MILITARY SPECIFICATION

CHAFF CARTRIDGE (TYPE RR-( )/AL),
GENERAL SPECIFICATION for

This amendment forms a part of Military Specification MIL-C-85003B(AS) dated 17 May 1983 and is approved for use within the Naval Air Systems Command, Department of the Navy, and is available for use by all Departments and Agencies of the Department of Defense.

Figure 2. Chaff Cartridge Critical Design Vibration, Takeoff Portion (2 minutes)

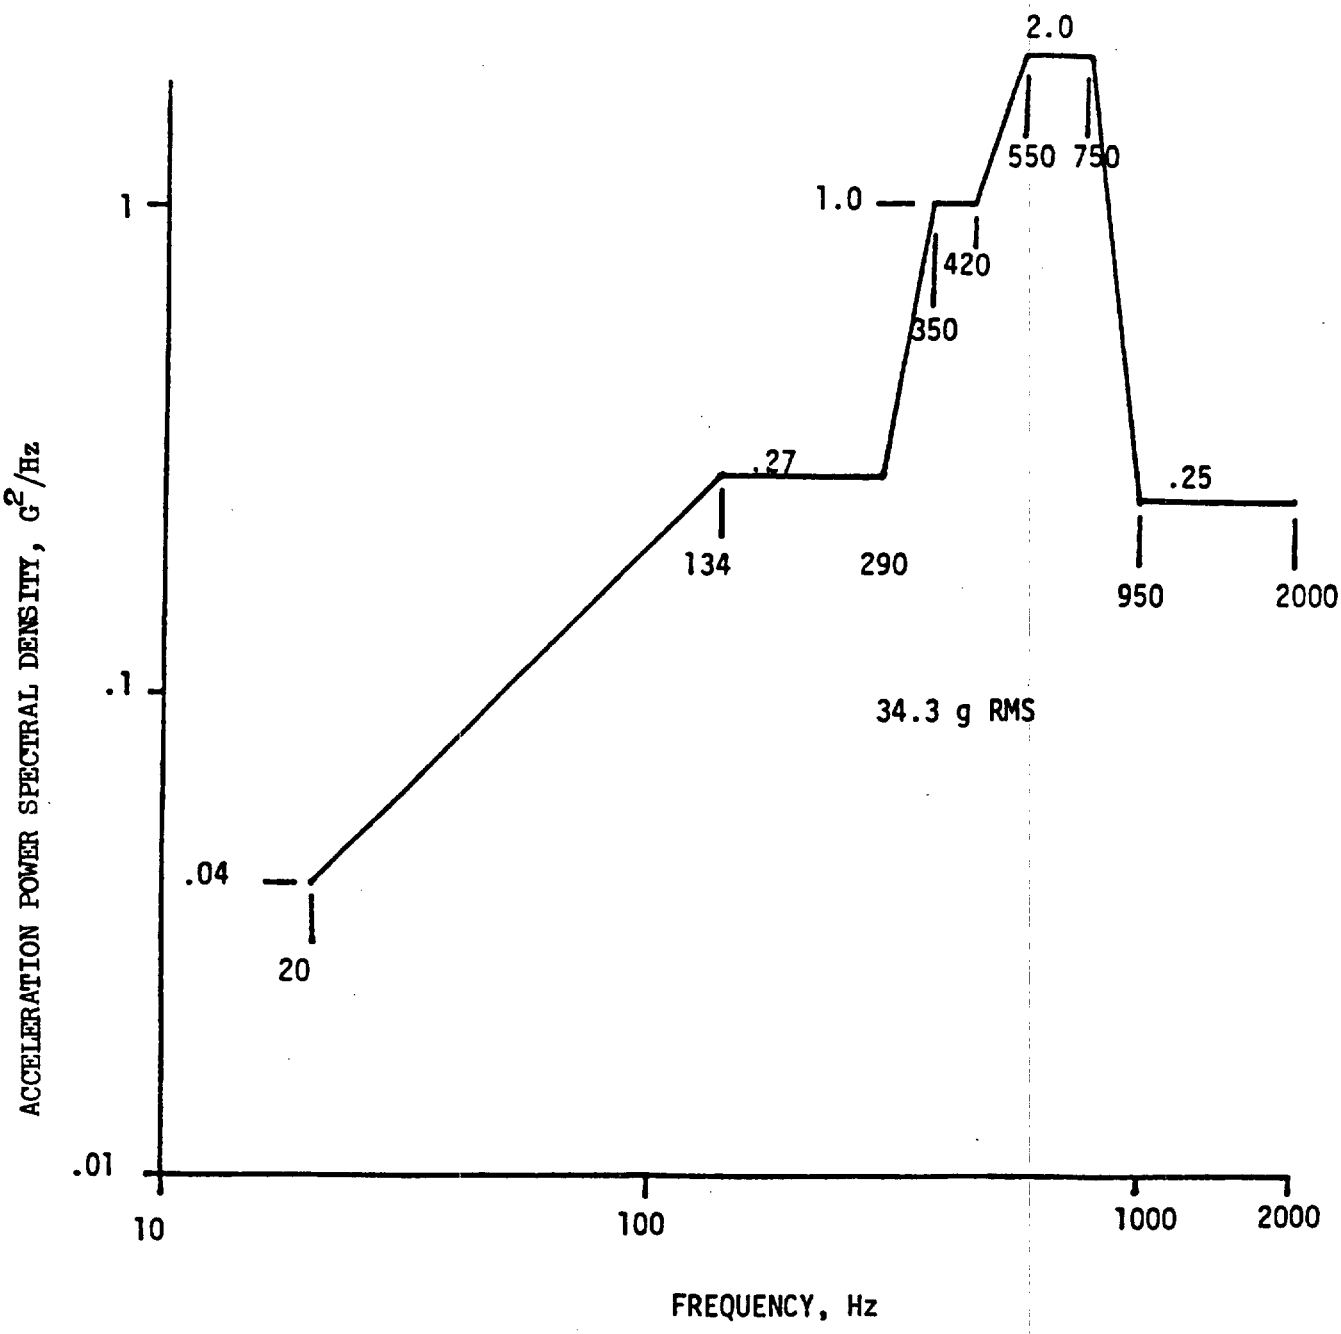
"4.10.6.1b Critical Design Vibration in accordance with Figure 2, for two minutes in each axis. Followed by Critical Design Vibration in accordance with Figure 3, for eight minutes in each axis."

FIGURE 2: Delete in its entirety and substitute new FIGURE 2, as PAGE 16a.

Figure 3. Chaff Cartridge Critical Design Vibration, Level Flight Portion (8 minutes).

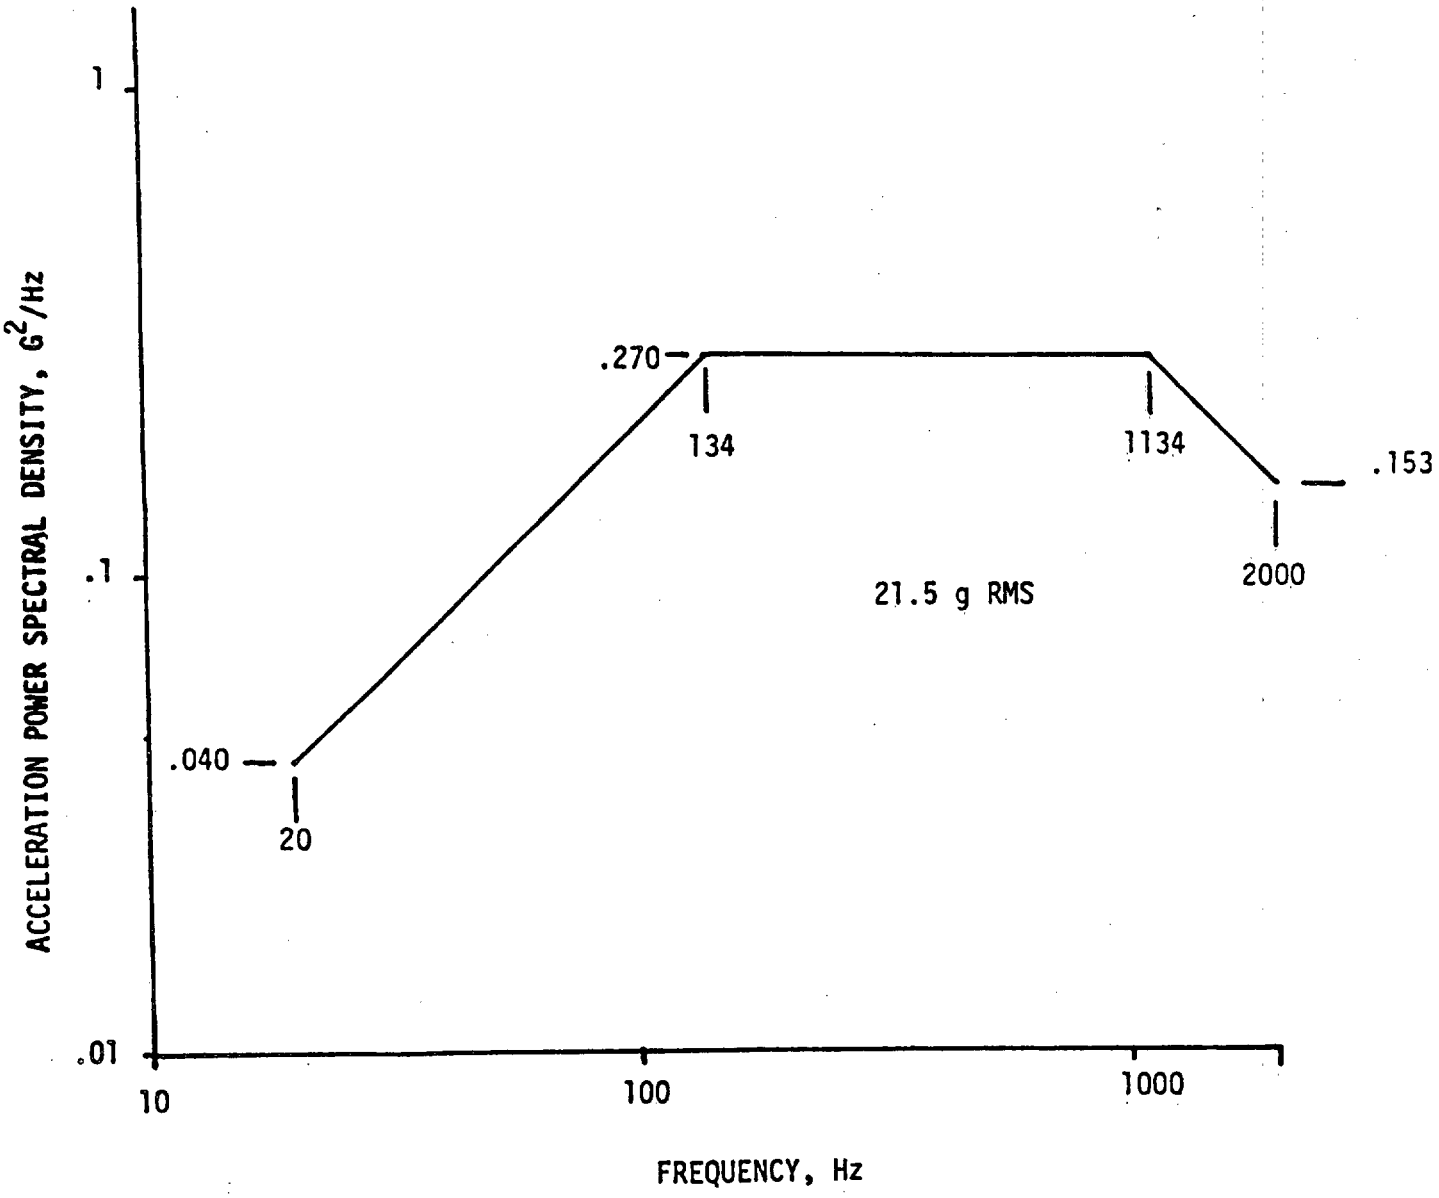
Following PAGE 16a insert new FIGURE 3, as PAGE 16b.
